PLANNING & ZONING COMMISSION FEBRUARY 7, 2023

C. New Construction-0507 97 Circle

TO: Michelle Eddy, CMC/CPM - Town Manager/Clerk
FROM: Kyle Parag, Plan Reviewer/Building Official - CAA
DATE: December 19, 2022
RE: Planning/Zoning/Architectural Guidelines review – 0507 97 CIR

LEE RESIDENCE
507 97 CIRCLE BLUE RIVER, COLORADO

SP1.0

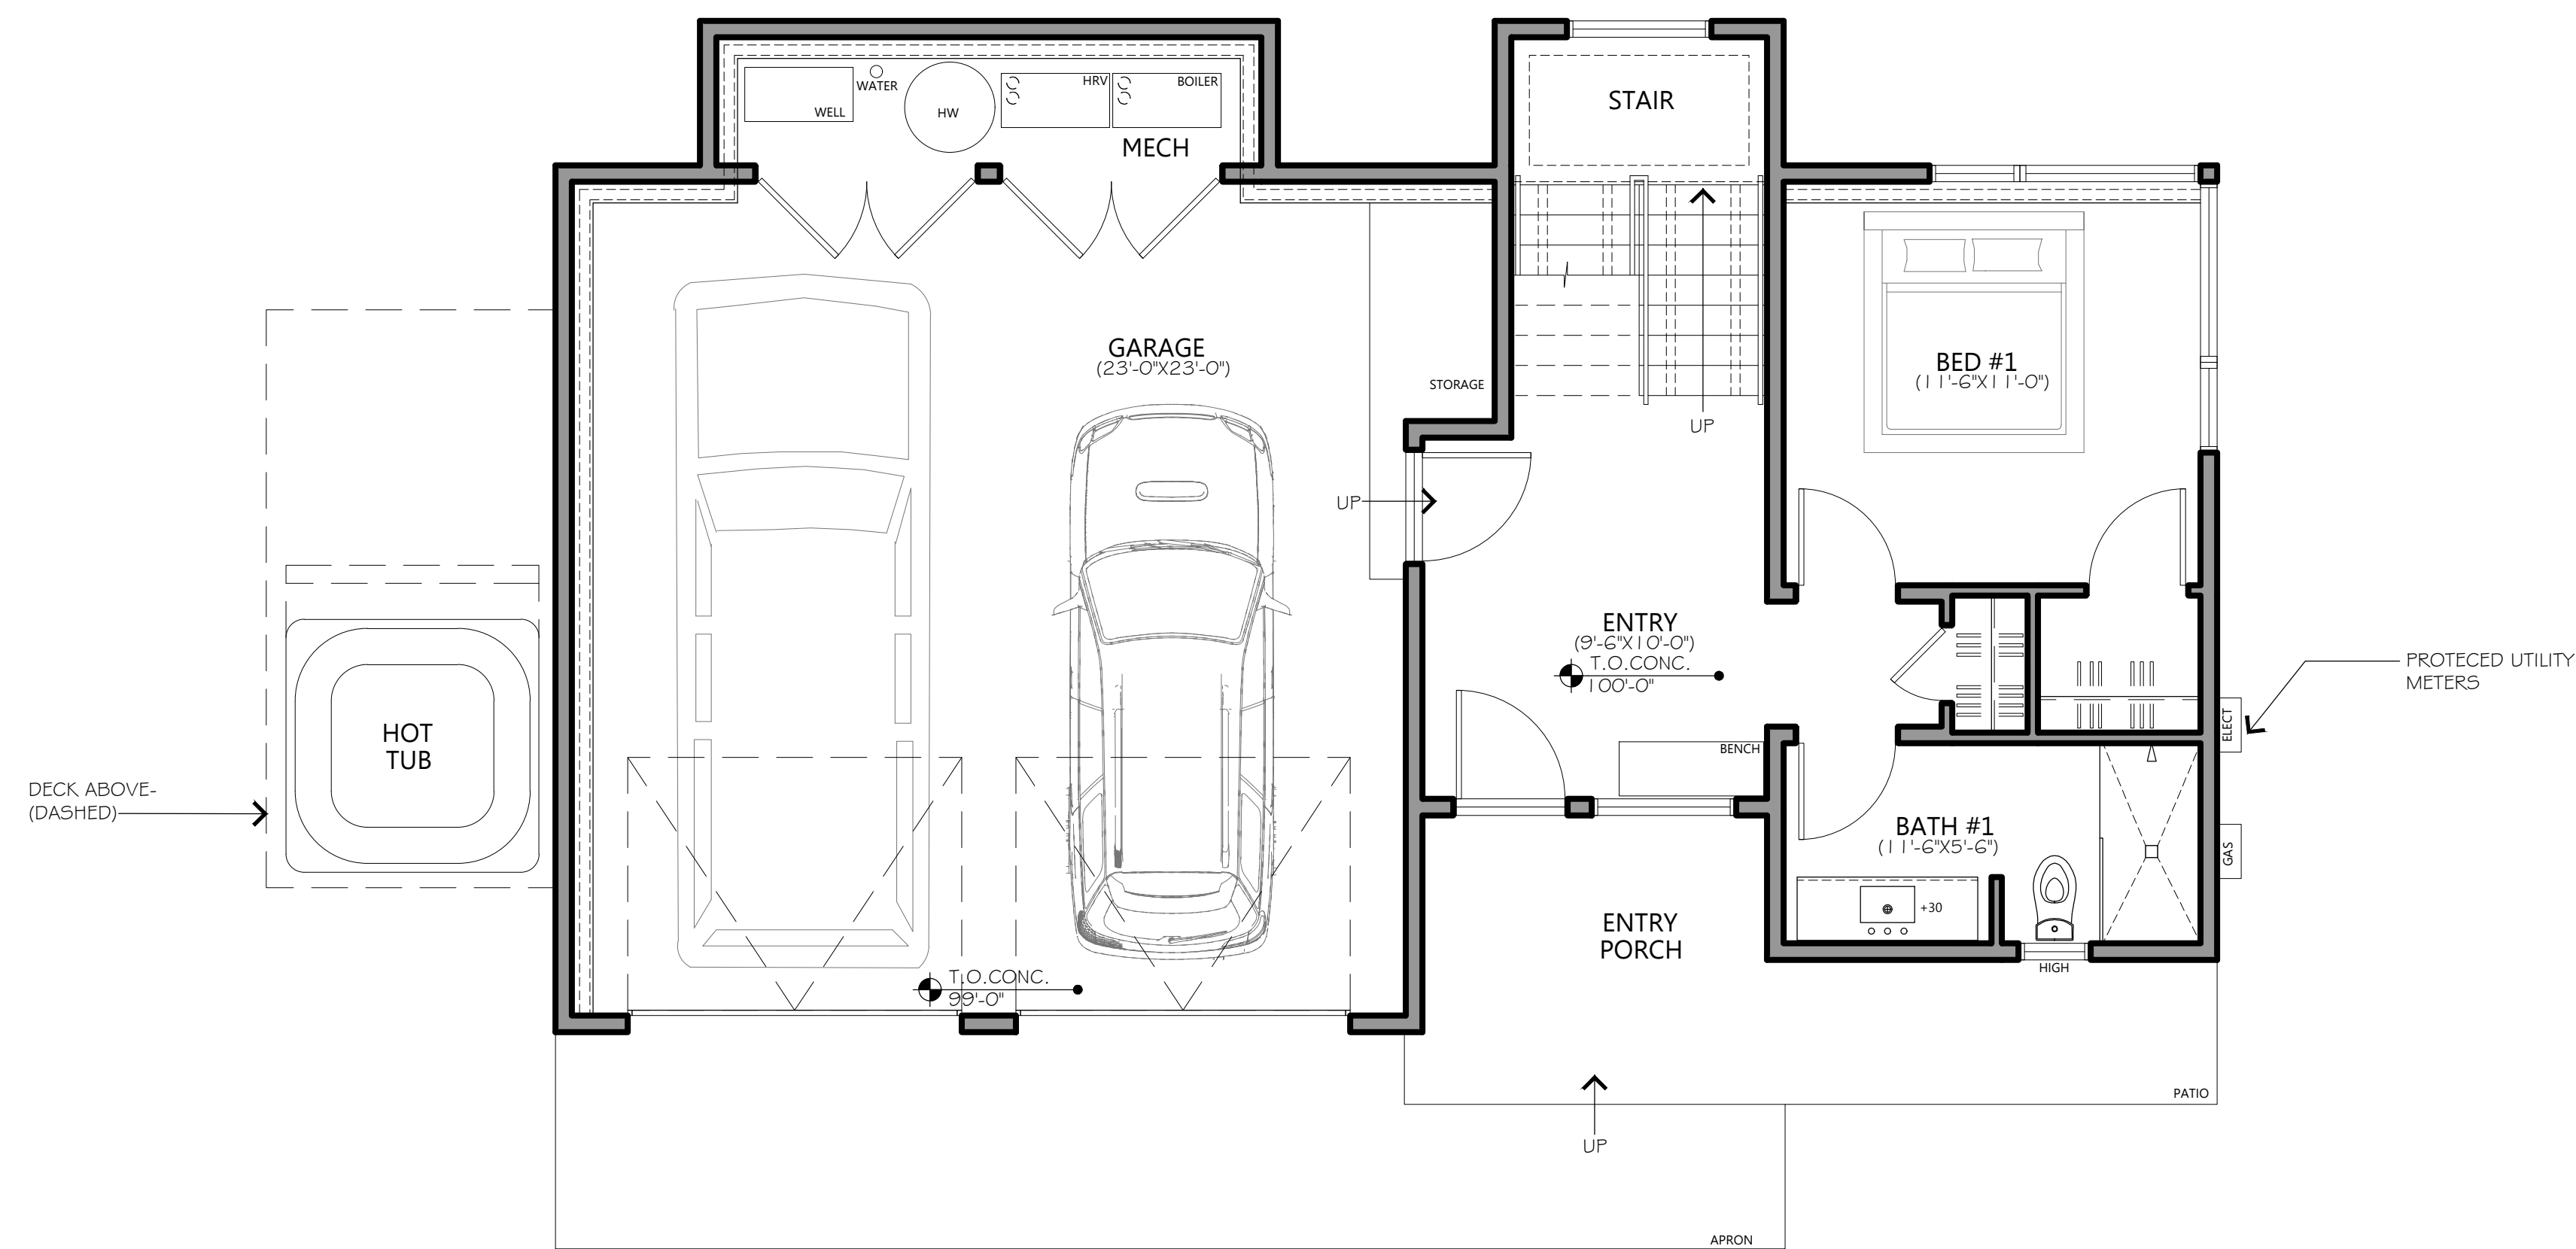
Setbacks: Proposed structure exterior walls are located beyond the required setbacks, but the roof overhang over the garage and front door may or may not encroach on required front setback. Elevations indicate a 2’ overhang beyond garage, which would encroach.

Parking Stds: 2 Enclosed parking spaces are provided. The property requires 3 spaces per design guidelines (F). The third parking space is provided outside but is located within the required front yard setback. Design guidelines (F) does

not permit any of the 3 to be provided in the setback.
Does not Comply

STANDARD	NOTES/REMARKS	SUBSTANTIAL COMPLIANCE
DEVELOPMENT STANDARD		
VI. B. Building Envelope	The submitted site plan depicts compliance, significant work is proposed to be completed in the front yard setback. Landscaping (screening) is depicted in side yard setback.	Y
VI. C. Building Siting	Structure is proposed in context with natural drainage patterns, contours, and landforms.	Y
VI. D. Grading and Drainage	Cut and fill slopes have been kept to a minimum and final grading is proposed to avoid unnaturally broad, flat surfaces.	Y
VI. E. Driveways	Proposed gravel driveway. Snow storage area calculations are provided, but locations are provided beyond the driveway improved area.	N
VI. F. Parking / Garages	The proposed attached 2 vehicle garage complies, However the required third space is provided in the front setback.	N
VI. G. Exterior Equipment and Satellite Dishes	No exterior equipment was identified	Y

VI. H. Easements and Utilities	R.O.W. easements are identified on the plans. Well location is located in front setback. Other easements are not identified.	Y
VI. I. Recreation Facilities	A Hot Tub is proposed under the deck.	Y
VI. J. Signage	No signage is indicated.	Y
VI. K. Pathways /Walkways	The proposed landings, pathways, and walkways comply.	Y
VI. L. Wetlands	Wetlands are identified on the plans. Location to wetlands is immediate, and disturbance of the wetlands impracticable to avoid. Applicant will need to demonstrate proper permits or creative construction methods before proceeding.	N
VI. M. Wildfire Regulations	Many of the required regulations are operational requirements post-construction.	Y
ARCHITECTURAL GUIDELINES		
VII. B. Building Forms	Proposed foundation walls merge with the existing grade, vertical walls appear to be illustrated with appropriate materials. Remaining building elements are wood or wood like appearance. Roof will shed on to lower low slope roof.	Y

A2.0

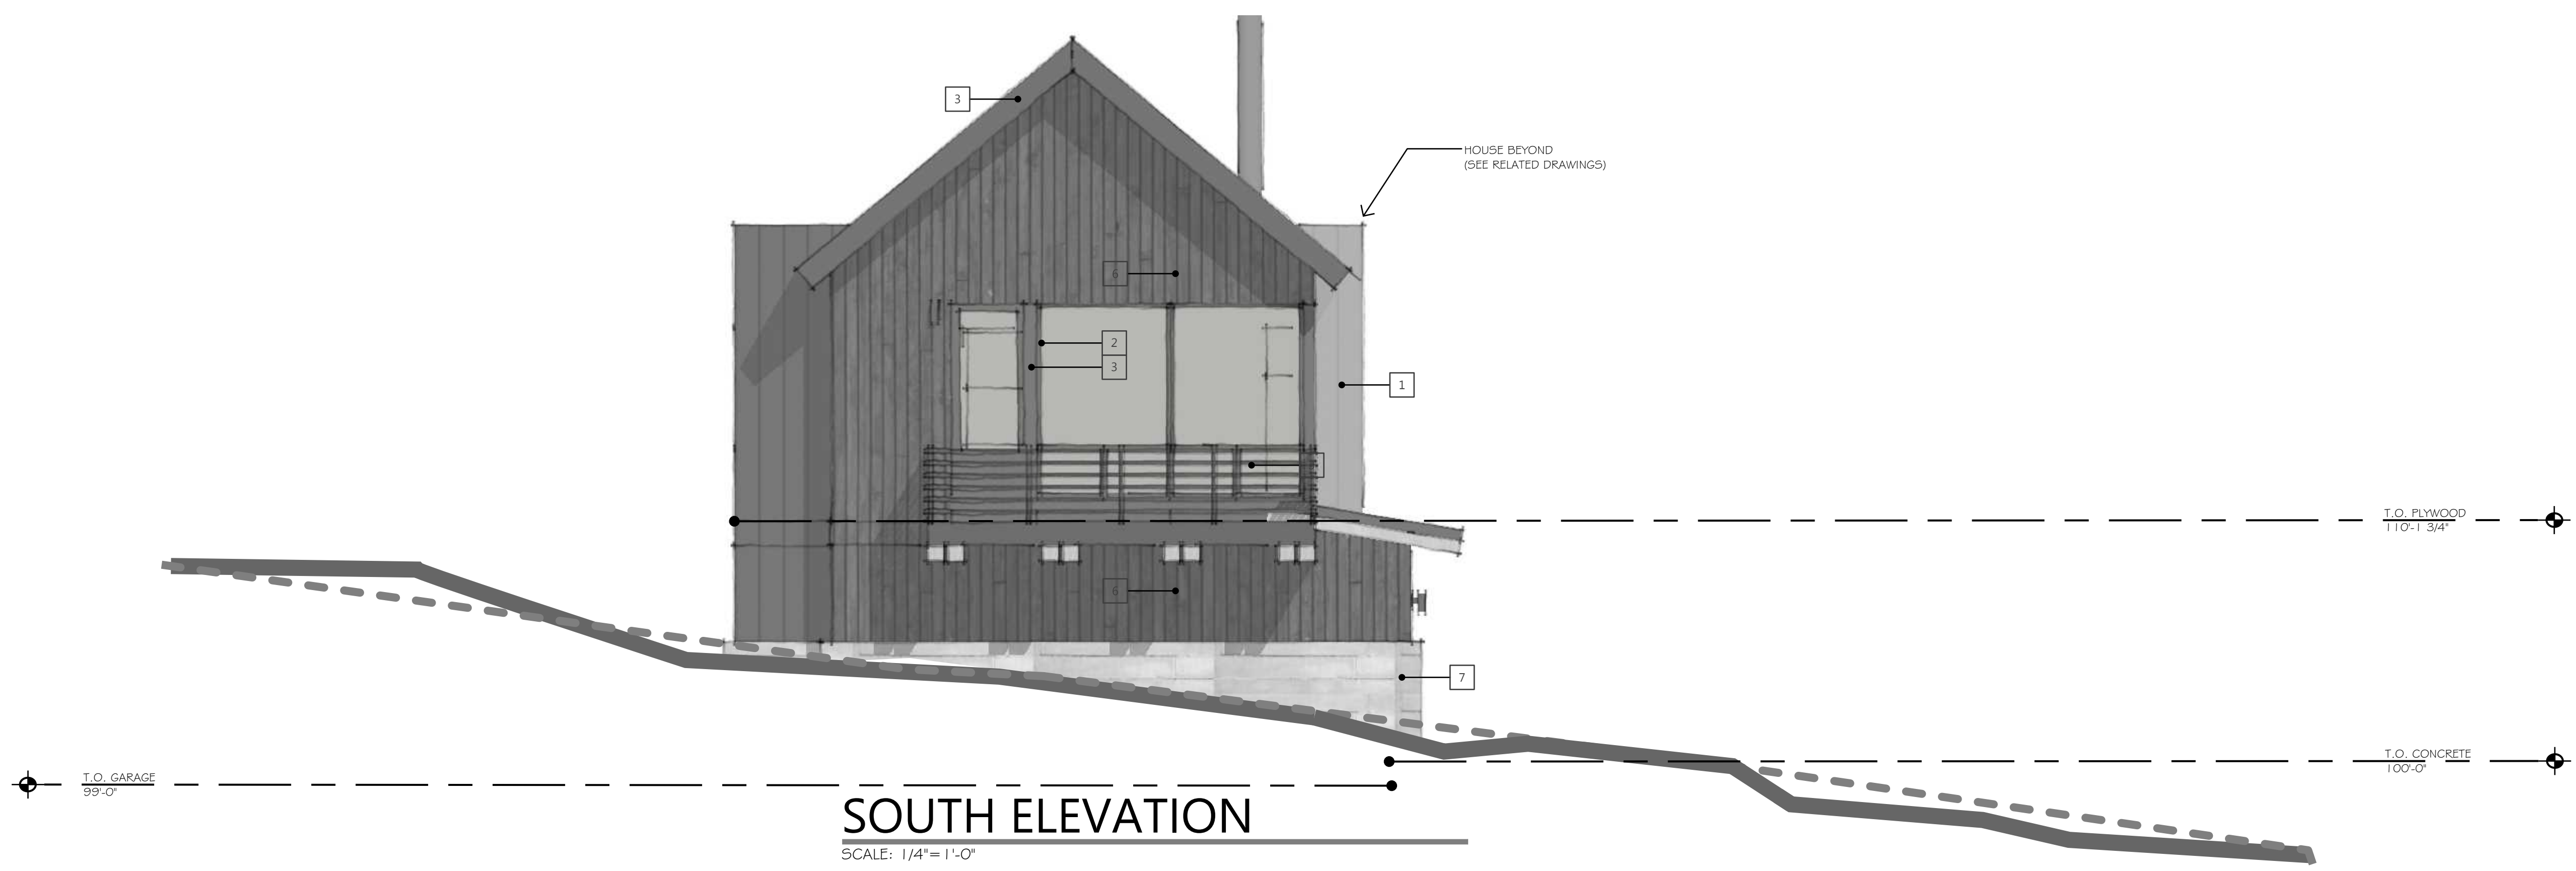
Height: Complies with required height limitations. The height at the highest roof ridge is proposed at 29’10” as measured from undisturbed soil elevation.

VII. C. Setbacks	Proposed structure exterior walls are located beyond the required setback, but the roof overhang over the garage and front door may or may not encroach on required front setback. Elevations indicate a 2' overhang beyond garage, which would encroach.	
VII. D. Building Height	Building complies with zoning district requirements. With a maximum height of 29' 10"	Y
VII. E. Roofs	Roof design is Gable roof. Primary slopes are 10:12 which is consistent with the suggested standards of 4:12 – 12:12 for primary roofs. The primary roof cover is identified as a standing seam metal. The proposed 2:12 slope of the metal roof depicted above garage and	Y

front door comply with requirements for secondary roofs. Heated gutter over garage is provided.	
VII. F. Exterior Wall Materials	Proposed exterior materials are ship lap, both horizontal and vertical.	Y
VII. G. Exterior Trim	Proposed trim colors are in general conformance.	Y
VII. H. Windows and Doors	Windows, doors, and garage doors are proportional to the structure and appear in general compliance.	Y
VII. I. Balconies and Railings	Railings are light in appearance and the pattern is largely open. Railing material and guard materials are proposed as a metal horizontal rail system.	Y
VII. J. Chimneys and Roof Vents	A metal flue finished to match roof is proposed. Flue is not enclosed within a chimney.	Y
VII. K. Exterior Colors	Proposed colors indicated on the color board are in general conformance.	Y
VII. L. Solid Waste Collection and Service Areas	None indicated.	N/A
SITE ELEMENTS		
VIII. A. Retaining Walls, Landscape Walls, Fences, and Screening	None indicated	N/A
